HDP – EMC Areas Review

During the February 1, 2018, NRC – Westinghouse publicly noticed teleconference the NRC and Westinghouse reviewed the 5 agenda items discussions/proposed path forward Westinghouse response to the January 24, 2018 agenda items identified at that time. During the February 1, 2018, teleconference a 6th agenda item was preliminarily discussed.

6. How many LSA survey units contain an elevated area? How many survey units contained a shared EMC/survey unit boundary? The EMC areas are of concern as in the future they may be excavated and brought to the surface. The EMC areas that have a shared boundary with a survey unit appear that the EMC area is also in an adjacent survey unit. The concern would be a dose consequence for the adjacent survey unit.

EMC Investigation Area within LSA 02-01

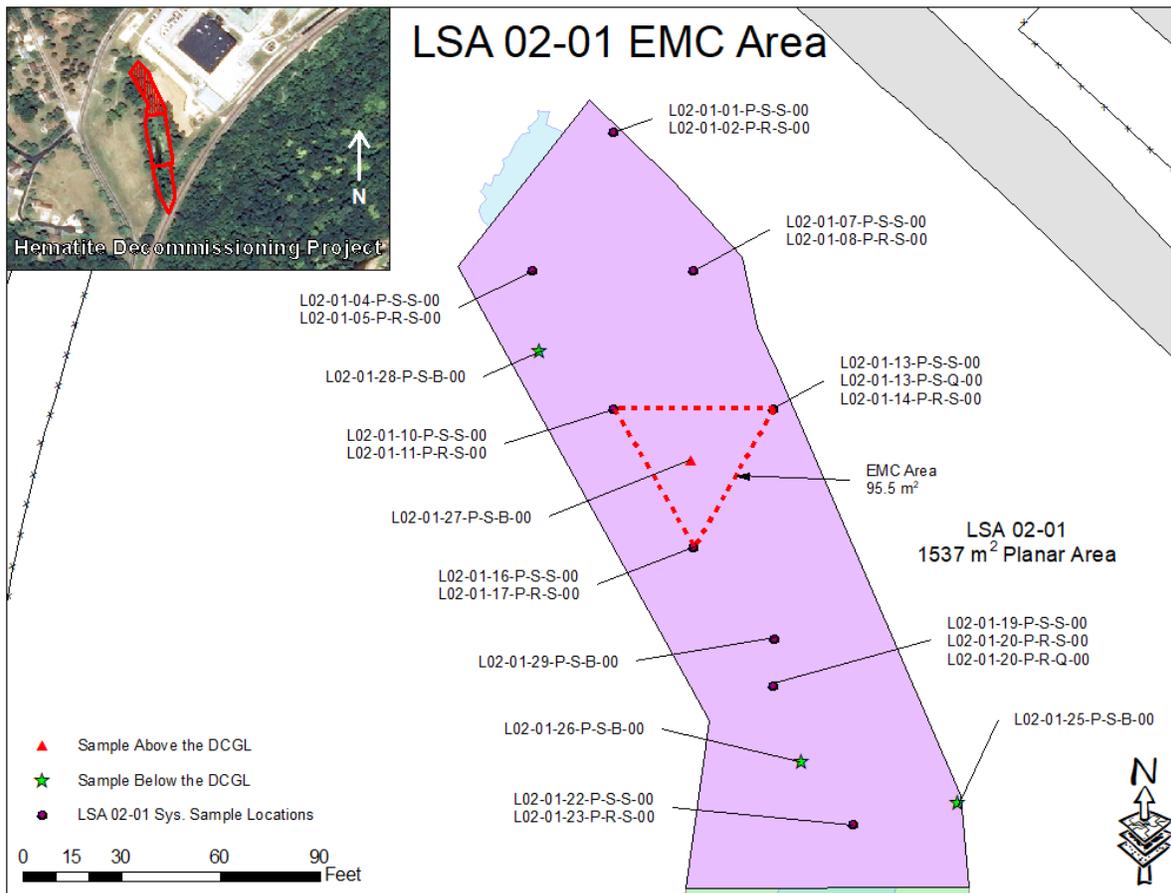
The size of the associated elevated area surrounding this biased location was determined by using the nearest “clean” systematic locations to define a polygonal area of 95.5 m² as calculated by GIS software.

EMC Investigation Area within LSA 02-02

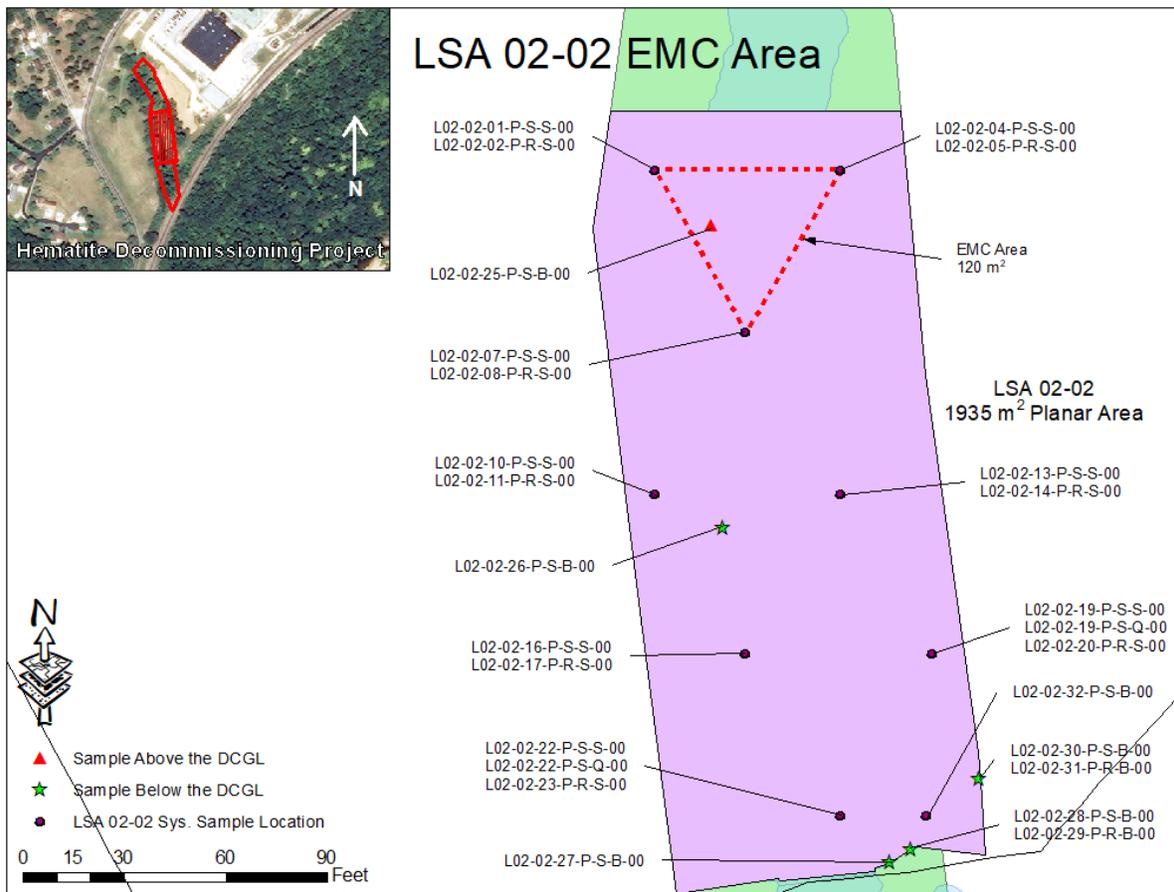
The size of the associated elevated area surrounding this biased location was determined by using the nearest “clean” systematic locations to define a polygonal area of 120 m² as calculated by GIS software.

EMC Investigation Area within LSA 02-03

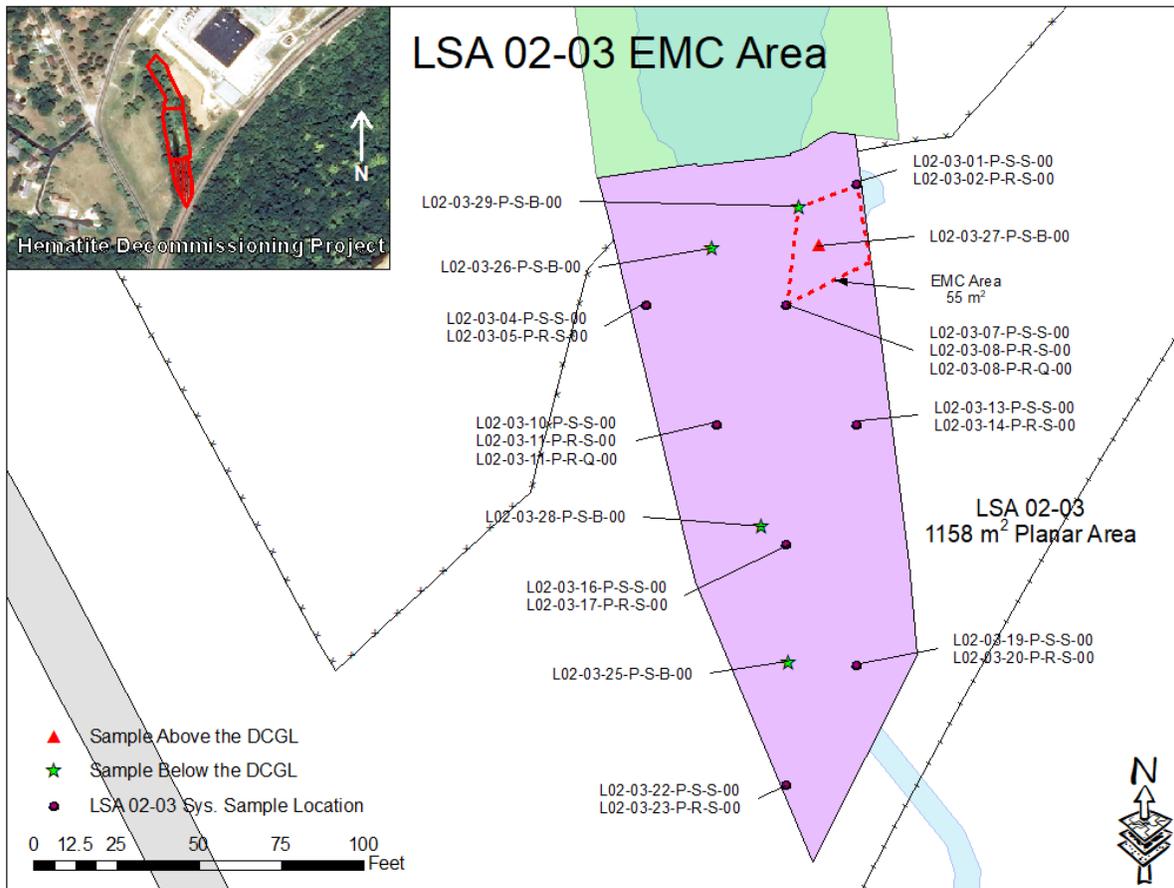
The size of the associated elevated area surrounding this biased location was determined by using the nearest “clean” systematic locations, biased sample locations, and the boundary of the SU to define a polygonal area of 55 m² as calculated by GIS software.

While it was not specifically stated in the FSSR for LSA 02-03 (Volume 3, Chapter 22) that scanning was also used to determine that the EMC area did not extend beyond the SU boundary, since the elevated area was due to Uranium a review of the GWS data does indicate that the area is very small, and clearly does not extend outside of LSA 02-03.

EMC Investigation Area within LSA 05-01

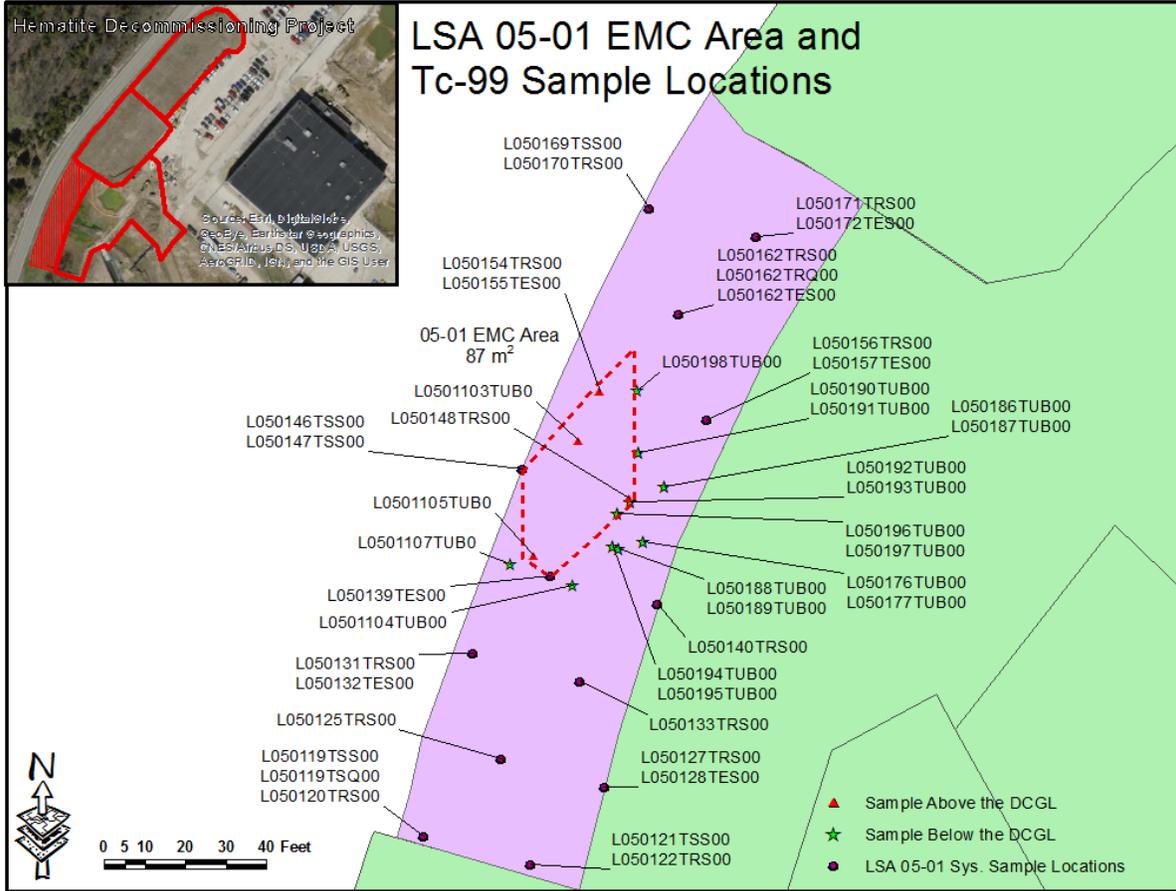
The size of the associated elevated area surrounding this biased location was determined by using the nearest “clean” systematic and biased locations to define a polygonal area of 87 m² as calculated by GIS software. This 87 m² polygon was placed around the elevated biased sample locations to define the area where the elevated sample activity remains within the SU. To the East, South, and West of the EMC area, there were a significant number of “clean” samples, creating a clear boundary. However to the North of the EMC area, there was less available sample data which required the Health Physics Staff to rely on professional judgment. Since LSA 05-01 borders a public roadway (State Road P), and excavation into the “right of way” of the roadway was limited by the Missouri DOT, less excavation (and thus less sampling) was performed in this area. Three elevated samples were identified to remain in the Northern portion of the EMC area. While there is less available “clean” sample data creating an easily defined boundary to the North, the area in question is still relatively small. There is less than 15 feet in linear distance from each of the elevated samples, to the nearest “clean” sample. Given these factors, the Health Physics Staff placed the Northern EMC boundary so that the three elevated sample points were completely enclosed within the 87 m² polygon, and that the all systematic samples collected above the Northern most boundary of the EMC area were significantly less than the DCGLs.

Furthermore, the Health Physics Staff considered given the radiological conditions of the EMC area what the maximum size of the EMC are could be without exceeding a SF of 1.0 for the survey unit. Evaluations determined that the area of the EMC would have to exceed 500 m² in order for the EMC evaluation to be unsuccessful. Knowing that the allowable maximum area is significantly larger than the actual estimated area provides an additional layer of confidence, but the purpose of the EMC evaluation is to determine the actual radiological conditions that remain in the area, not the allowable maximum, therefore the 87 m² polygon is considered appropriate.

EMC Investigation Area within LSA 08-01

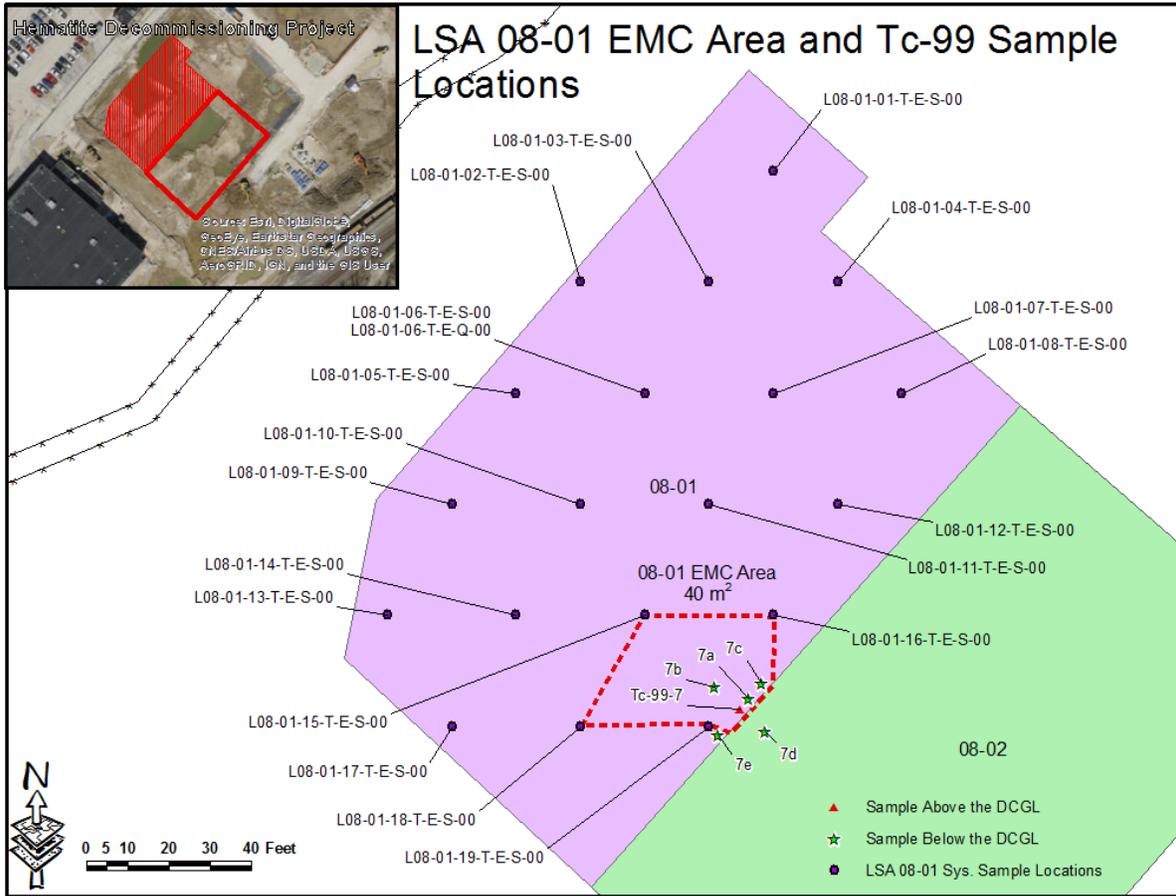
The size of the associated elevated area surrounding this biased location was determined by using the nearest “clean” systematic and biased locations and the boundary edges of the SU itself to define a polygonal area of 40 m² as calculated by GIS software.

While not specifically stated in the FSSR for LSA 08-01 (Volume 3, Chapter 12), sample points 7d, and 7e in the figure below were included to provide additional confidence that the general size of the elevated area is relatively small compared to the larger “assumed” EMC Area. Using sample points 7b, 7c, 7d, and 7e in the figure below, the EMC area could be estimated to be 14 m². However this smaller area was not used as point 7d is in the neighboring LSA 08-02.

Since the estimated AF of 40 m² was chosen to be sufficiently conservative, and the SU still passed the EMC evaluation, it was determined that additional sampling would not be beneficial as it would only serve to reduce the estimated dose for LSA 08-01.

EMC Investigation Area within LSA 08-10

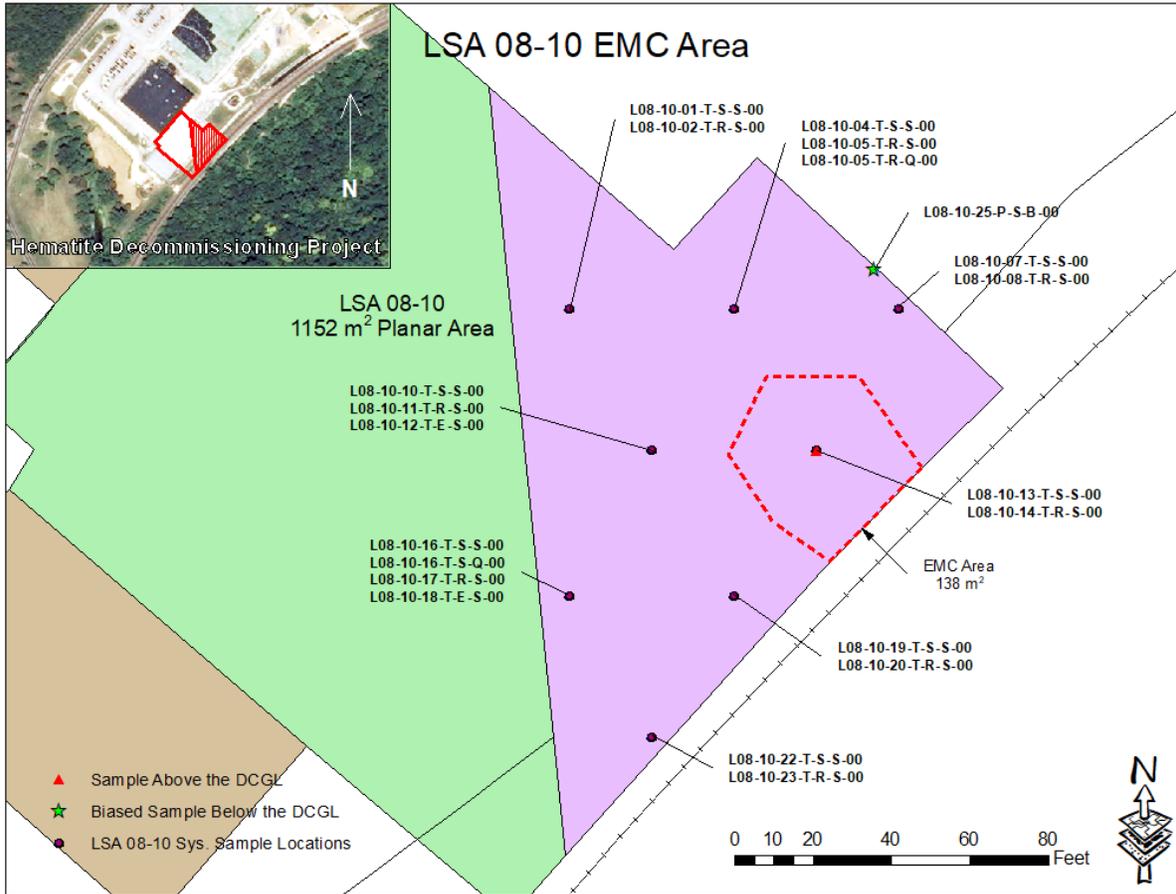
One sample in LSA 08-10 was identified to contain elevated levels of Tc-99 as indicated by the analysis, performed at the offsite laboratory, of the systematic soil samples collected in the SU. While no individual nuclide within the sample exceeded the appropriate DCGL_w, the SOF for the sample (1.11) did exceed a Uniform SOF value of 1.0.

Therefore, an Elevated Measurement Comparison (EMC) evaluation was performed for LSA 08-10 as required by Procedure HDP-PR-FSS-721 Final Status Survey Data Evaluation. The size of the associated elevated area surrounding this location was determined by using half the distance to the nearest “clean” systematic locations and the boundary edges of the SU itself to define a polygonal area of 138 m² as calculated by GIS software. Following the steps presented in Section 8.6.7 of HDP-PR-FSS-721, the DCGL_{EMCS} for all nuclides were calculated based on the nuclide-specific area factors corresponding to 138 m².

While not specifically stated in the FSSR for LSA 08-10, the following assumptions were made to determine the estimated size of the EMC area. Review of previously performed characterization data showed no other similar areas of elevated activity, and the GWS data did not indicate the presence of any elevated gamma measurements. As no individual nuclide exceeded the individual DCGL_w, and characterization data supports the conclusion that the slightly elevated contamination is not widespread, the elevated area was assumed to be very small in nature. In order to determine how large a hypothetical hot spot could be and still meet the unrestricted release criteria, a reverse EMC calculation determined that at these soil concentrations the hot spot would have to exceed 500 m² before additional remedial actions became necessary for the SU to meet release criteria.

Next, in an attempt to accurately estimate the appropriate size of the elevated area, the distribution of the systematic samples was reviewed. Since each systematic sample spatially represent a certain portion of the SU, the elevated area was estimated by using half the distance to the nearest “clean” systematic locations and the boundary edges of the SU itself to define a polygonal area (as seen below). While it is still assumed that the elevated area is quite small in nature, it was determined that by expanding the EMC area all the way to the SU boundaries the estimate of 138 m² was sufficiently conservative, and more accurately reflected the residual dose in the SU compared to using the “hypothetical worst case” scenario.

EMC Investigation Area within LSA 08-01

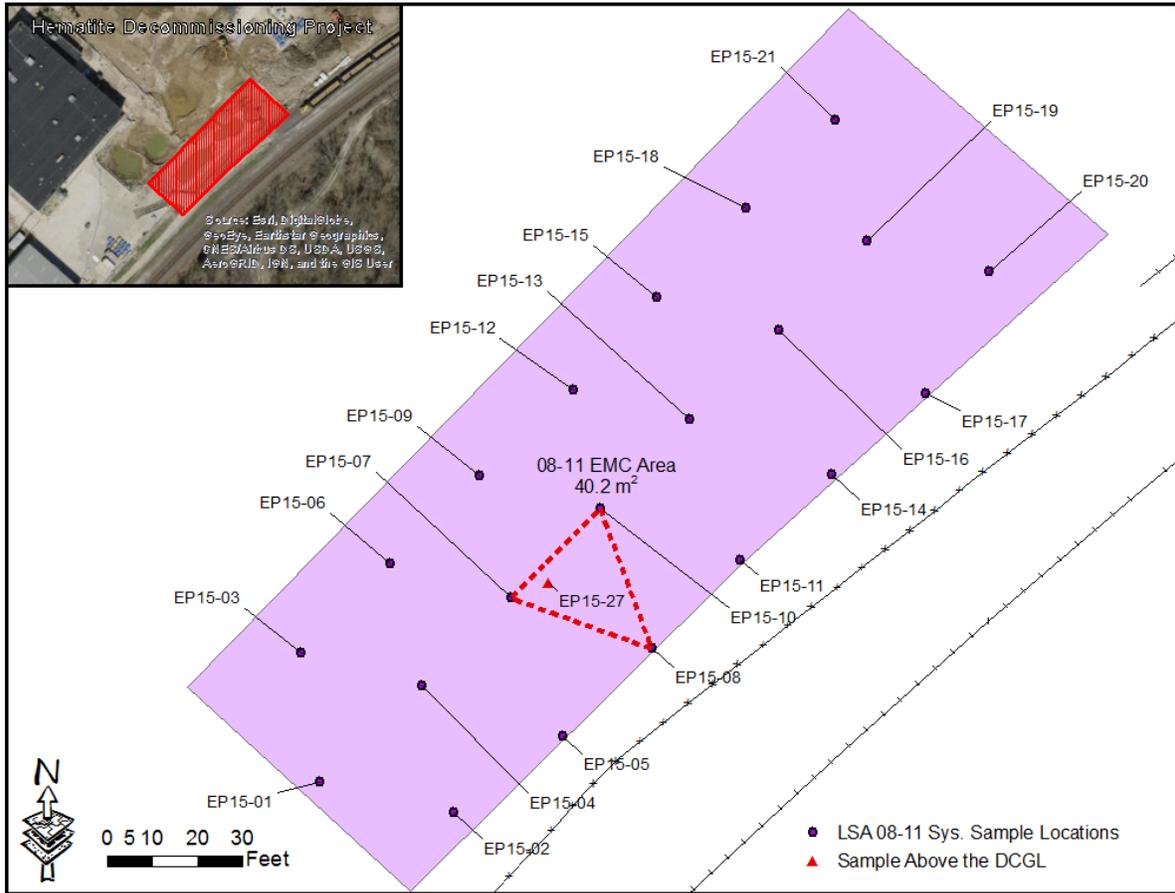
The size of the associated elevated area surrounding this biased location was determined by using the nearest “clean” systematic and biased locations and the boundary edges of the survey unit itself to define a polygonal area of 40.2 m² as calculated by GIS software.

EMC Investigation Area within LSA 08-12

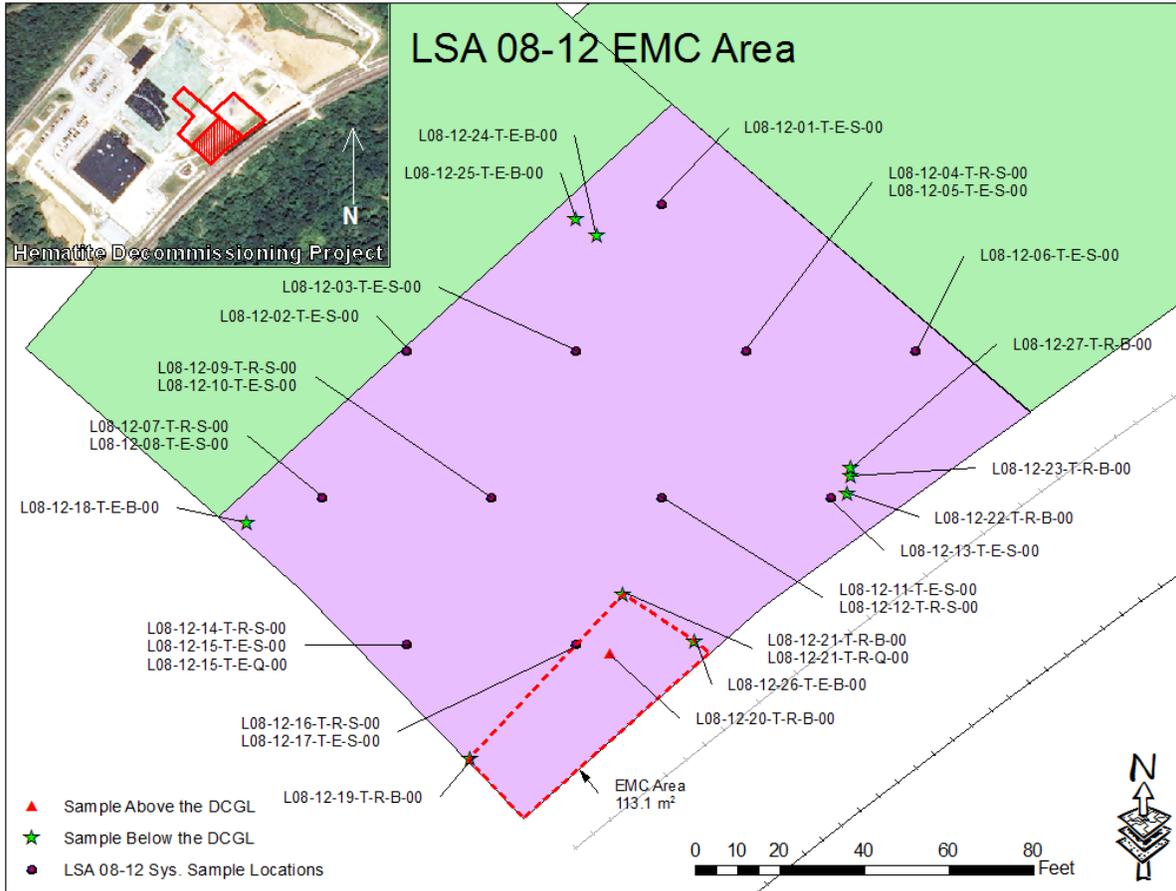
The size of the associated elevated area surrounding this biased location was determined by using the nearest “clean” systematic and biased locations and the boundary edges of the survey unit itself to define a polygonal area of 113.1 m² as calculated by GIS software.

While not specifically stated in the FSSR for LSA 08-12, the following assumptions were made to determine the estimated size of the EMC area. Review of the surrounding sample data showed that the nearest three clean sample points were approximately 10, 15, and 20 feet away from the elevated area respectively, indication that the EMC area is quite small. So the decision was made to conservatively expand the EMC area outward to the survey unit boundaries in order to give a high level of confidence that the elevated area had been completely encompassed and accounted for in the final survey unit dose assessment.

NOTE: During review of the LSA 08-12 data, a minor typographical error was identified that will require correction, and re-submittal of Volume 3, Chapter 21, to Revision 2 (LSA 08-09, LSA 08-12 and LSA 08-13). The EMC determination inadvertently used the Excavation DCGLs, when the Root DCGLs should have been used, thus slightly increasing the EMC dose estimate from 1.25 mrem/year to 3.5 mrem/year. The Root AFs were properly applied, as were all other applicable DCGLs to the remaining soil samples in the survey unit. The survey unit still meets the unrestricted release criteria, with a survey unit total dose estimate of 11.68 mrem/year (using the final ground water dose contribution), well below the 25 mrem/year dose criteria.
